Three Mile Island Nuclear Station Unit 2 (TMI-2)
Operating License No. DPR-73
Docket No. 50-320
TMI-2 Additional Information of Cork Seam

RESPONSE TO REQUEST FOR ADDITIONAL INFORMATION ON TMI-2 CORK SEAM CONTAMINATION

TABLE 1

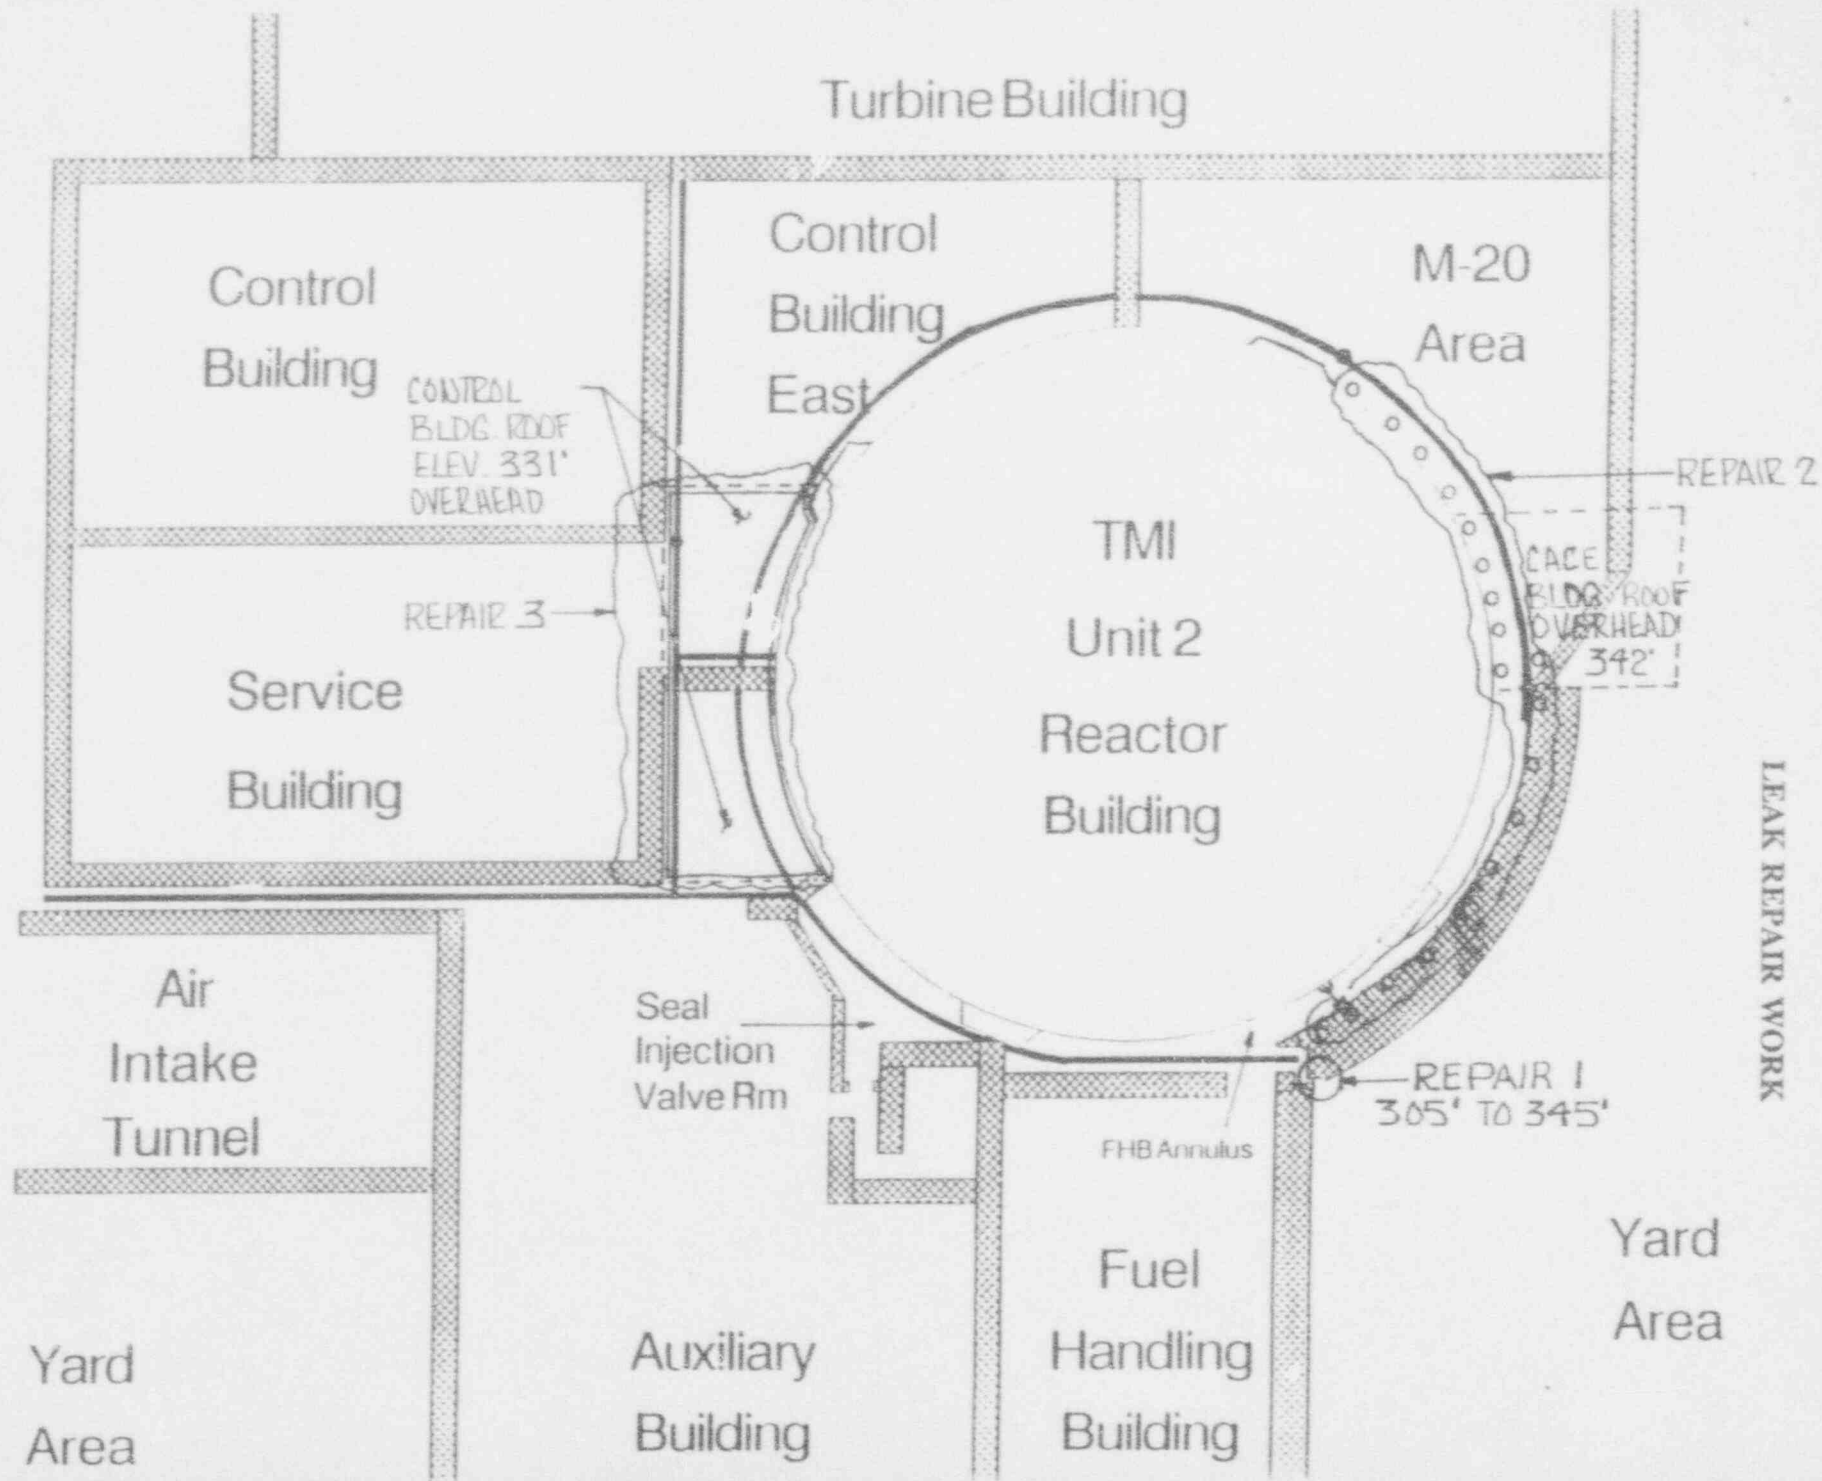
3. Provide an estimate of the amount of water and radioactive contamination in the cork seam.

RESPONSE: The cork seam is one to two inches wide, approximately 600 feet in linear length, and filled with cork to a depth of three to five feet, depending on location. It was originally estimated that there could be a maximum of 1000 gallons of contaminated water in the seam. However, the pumping experience of December 3 and 6, 1993 indicates that there is much less than 1000 gallons of contaminated water in the cork seam. The activity level of a water sample taken from a one-inch diameter core-bored

hole in the Auxiliary Building is listed in Table 1. This hole is located five feet from the Seal Injection Valve Room (SIVR). A water sample extracted from a one-inch diameter core-bored hole in the M-20 area shows no contamination in that area. It is estimated that there is an additional 200 gallons of non-contaminated (i.e., "clean") water in the M-20 area cork seam.

Therefore, based on samples taken over the course of the cleanup including the water sample noted above, the estimate of the total contamination in the seam outside the SIVR is 5 Ci of Cs-137 and 1 Ci of Sr/Y-90. Using these values as a basis, the estimate of the contamination in the cork seam in the SIVR is 15 Ci of Cs-137 and 4 Ci of Sr/Y-90.

FIGURE 2

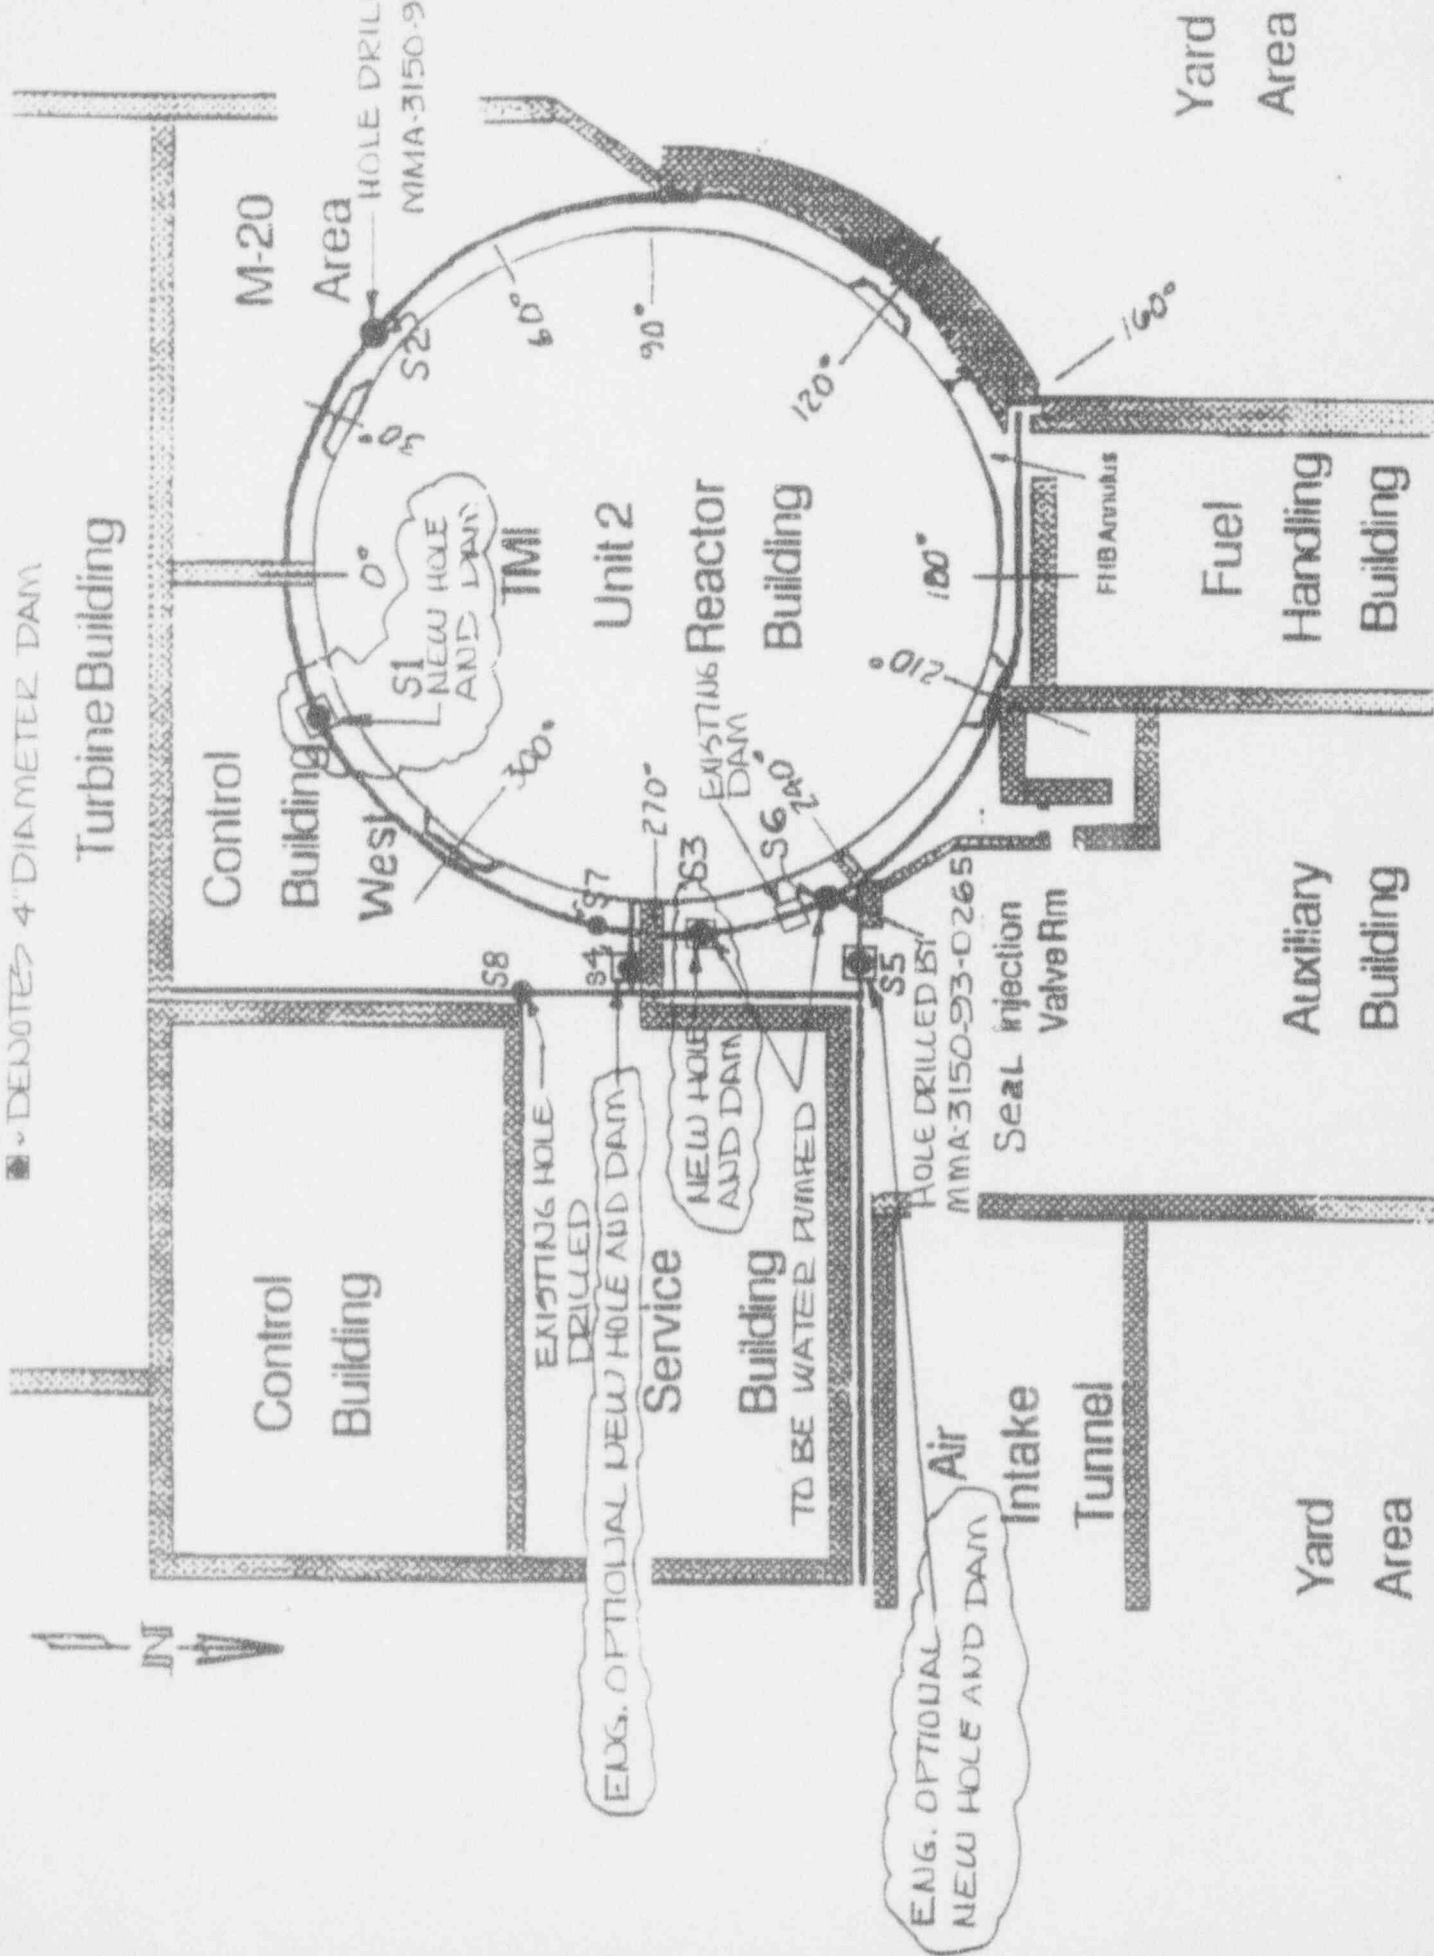
Describe your monitoring program to monitor water level and contamination containment in the cork seam once the facility enters PDMS.

RESPONSE: During the removal of water from the cork seam, four four-inch diameter dams will be installed to prevent contamination from spreading and to provide monitoring locations, and two additional one-inch diameter holes (2 currently exist) will be drilled for pumping (See Figure 2). The dams will be made from an injectable polyurethane grout. This material adheres to wet surfaces and expands to form a closed cell foam that will fill any gaps in the concrete adjacent to the cork seam. In addition, after the dams and pumping/monitoring holes are installed and the water is removed, GPU Nuclear will evaluate whether additional actions are required, i.e., removal of cork material or capping of the cork seam.

After the water removal process has been completed, a liquid level monitoring device will be inserted in each of the four sections in the one-inch diameter holes. At least monthly, for a period of one year, these holes will be monitored for water entering the seam. The monitoring program will be reevaluated after the initial one year period.
